U.S. EPR RLBLOCA Topical Report: Round 3 RAI

***AREVA NP and the NRC
September 10, 2008***

- > Background**
- > Meeting objectives**
 - ❖ Describe approach to address 3rd Round RAI**
 - ❖ Obtain NRC feedback on proposed approach**

RAI 31 - Cold Leg Condensation Effect

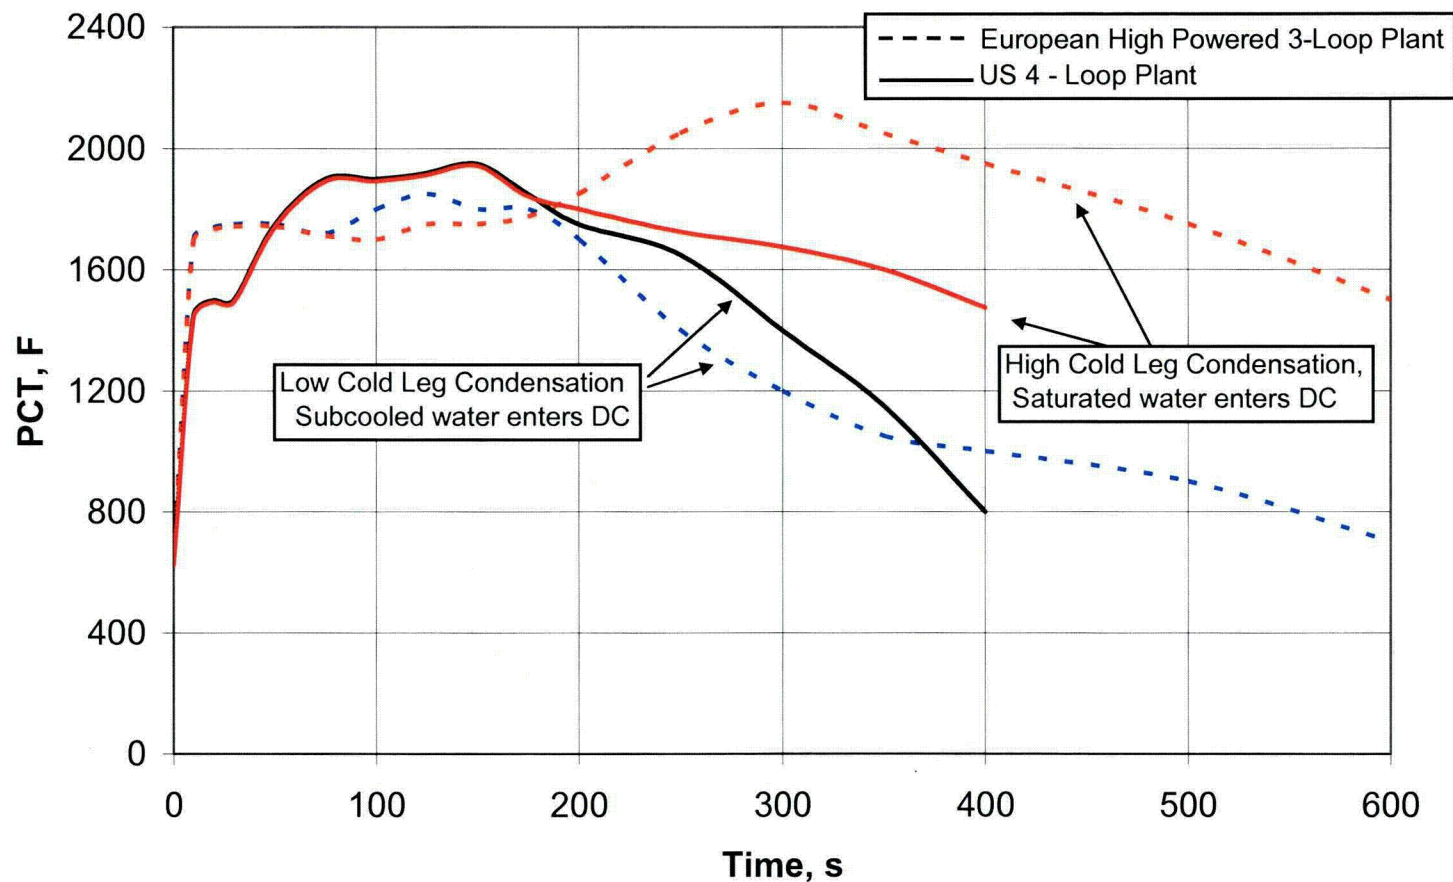
RAI 31 – Response

- > Cold leg condensation is important to the prediction of downcomer boiling phenomena and will be modeled in a new case set**

- > AREVA NP will document transition package sensitivity studies in revised ANP-10278P**

RAI 25 – Sensitivity Study Example Maximum PCT Case (65% DEGB)

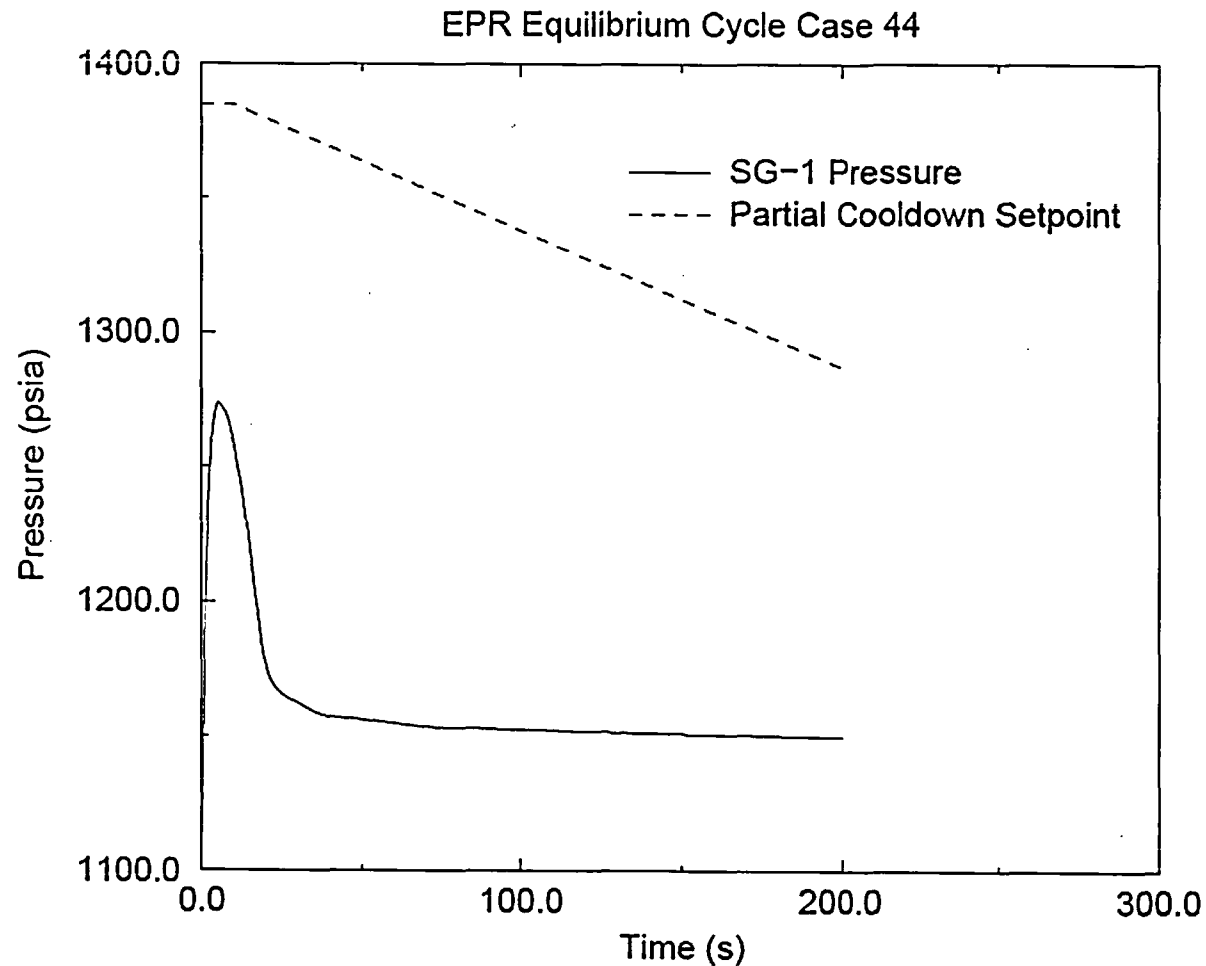
RAI 25 – Response

- ❖ **Steam generator is instantaneously isolated at the time of the break**
- ❖ **The secondary side relief or safety valves not modelled because they are not actuated for limiting breaks**
- ❖ **Automatic steam generator partial cooldown to 870 psia (setpoint reached only for break sizes of 1.5 ft² or less, 15% DEGB)**
- ❖ **No depressurization for these smaller breaks is conservative**
- ❖ **Refill of loop seals will only occur at extended times and for pressures much below lowest steam generator pressures**

> Sensitivity studies

Topical Report Figure A-13, Core Inlet Mass Flux

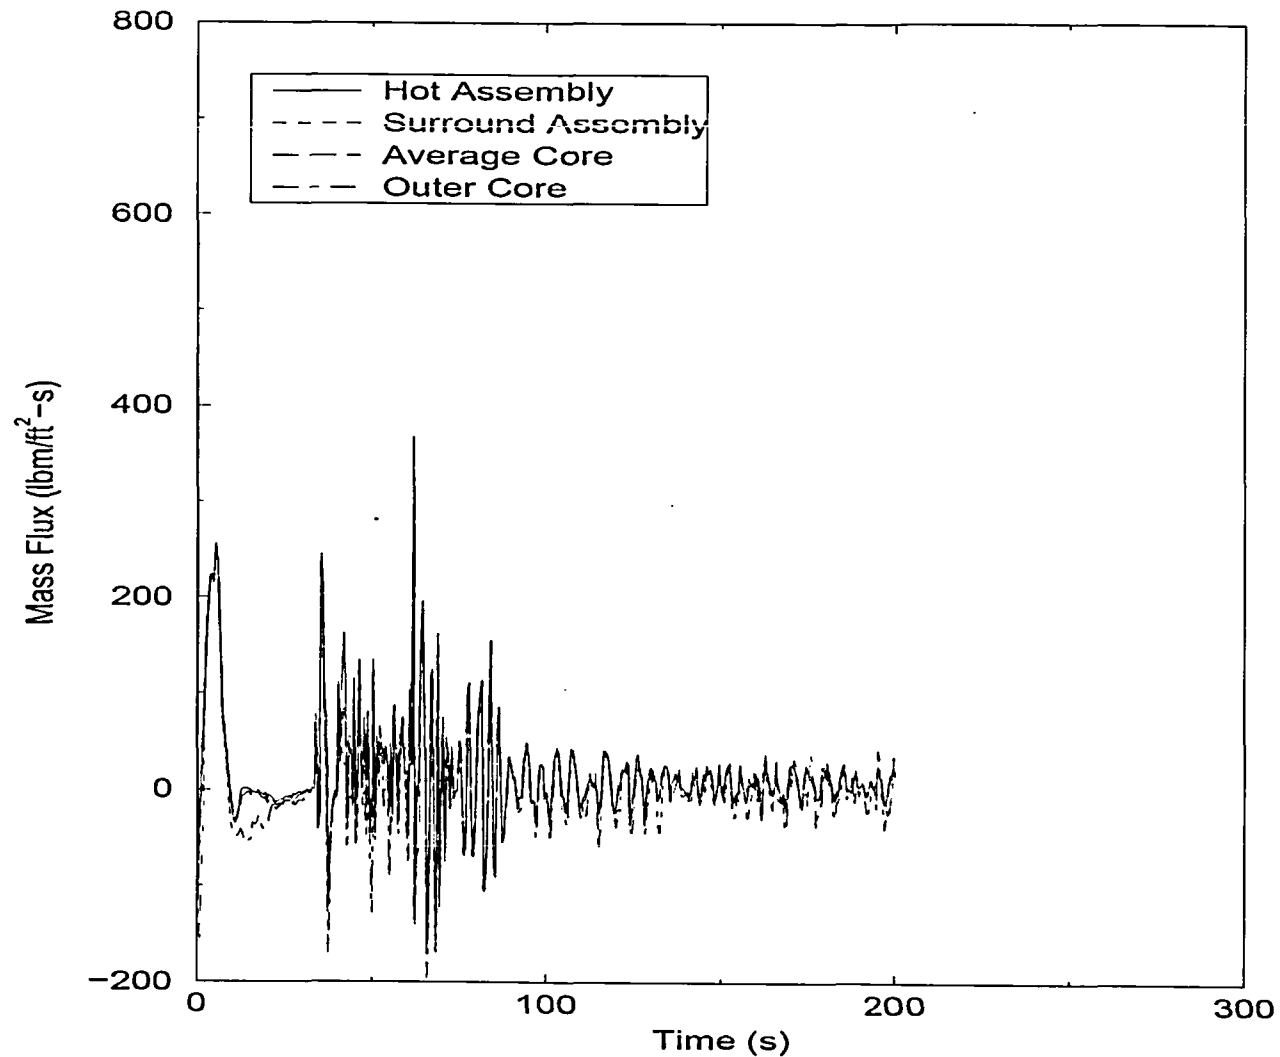
RAI 26 - Response

- > **Flow oscillations question to be resolved by building on the technical basis of EMF-2103(P)(A):**
 - ♦ Describe the particular oscillatory phenomena of interest, distinguish between cold-leg accumulator, manometer, and loop SI driven
 - ♦ Identify the analytical and experimental basis
 - ♦ Revisit earlier code-to-data comparisons drawn from existing code assessments (EMF-2102) to address code performance in general and at different scales

- > **Additional sensitivity analysis will examine the influence of various phenomenological contributors on the magnitude of oscillations and clad temperature, including**
 - ♦ Accumulator/SI temperature
 - ♦ Interfacial heat transfer (condensation) – increase in condensation applied for RAI 31 are expected to reduce any clad temperature sensitivity to oscillations
 - ♦ Others, as necessary; however, modification of core inlet resistances is not phenomenologically based; thus, not an appropriate study

- > **Assess sensitivity with appropriate measures (i.e., clad temperature, liquid level, and mass flux)**

RAI 33 – Comparison 1979 $\pm 2\sigma$ with ORIGIN-2

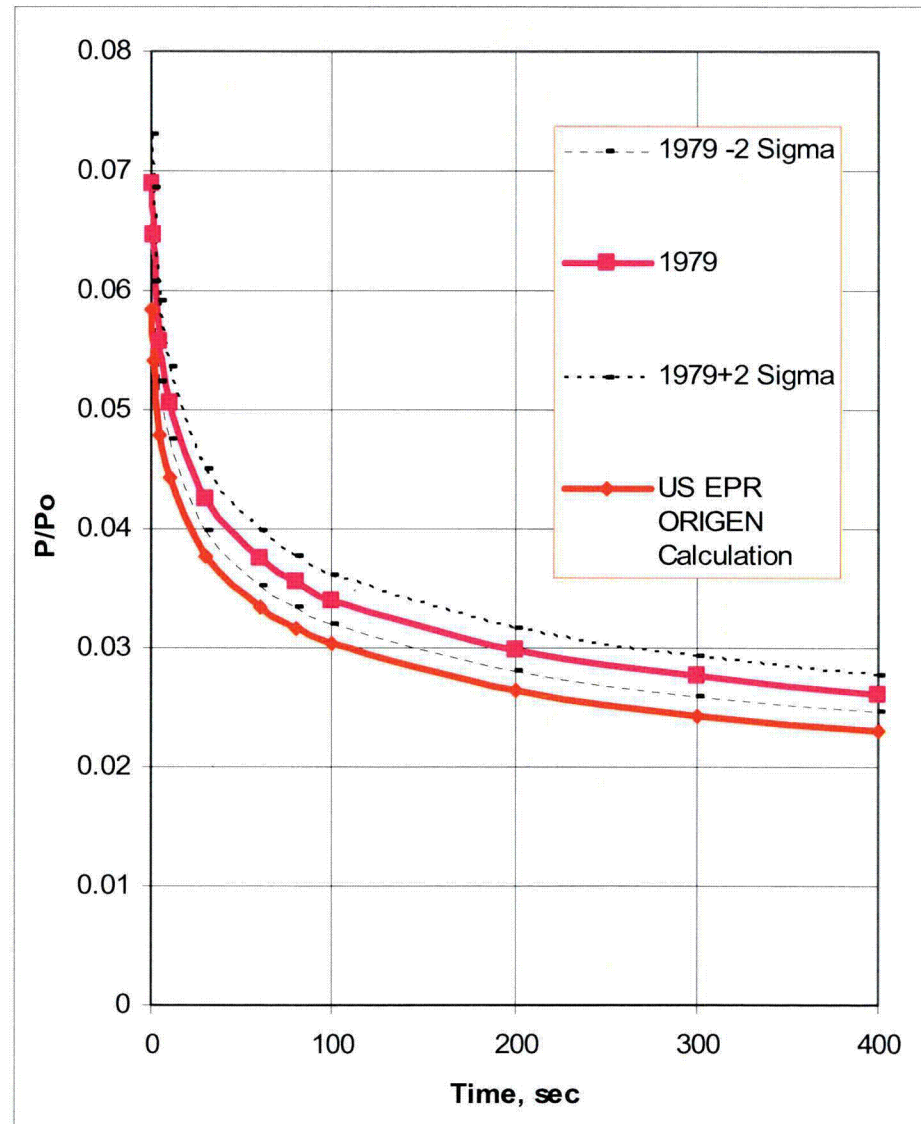
RAI 33 – Response

- > Provide justification for EMF-2103 Rev. 0 method**
- > In accordance with Regulatory Guide 1.157, calculate the decay heat based on the 1979 ANSI/ANS standard**
- > The standard is applied conservatively**
 - ♦ Infinite operating time at full power**
 - ♦ All fissions assumed from U-235**
- > Uncertainty sampling base - 1979 ANSI/ANS standard**
 - ♦ Gaussian distribution**
 - Mean = 1.0**
 - Standard deviation = 3%**
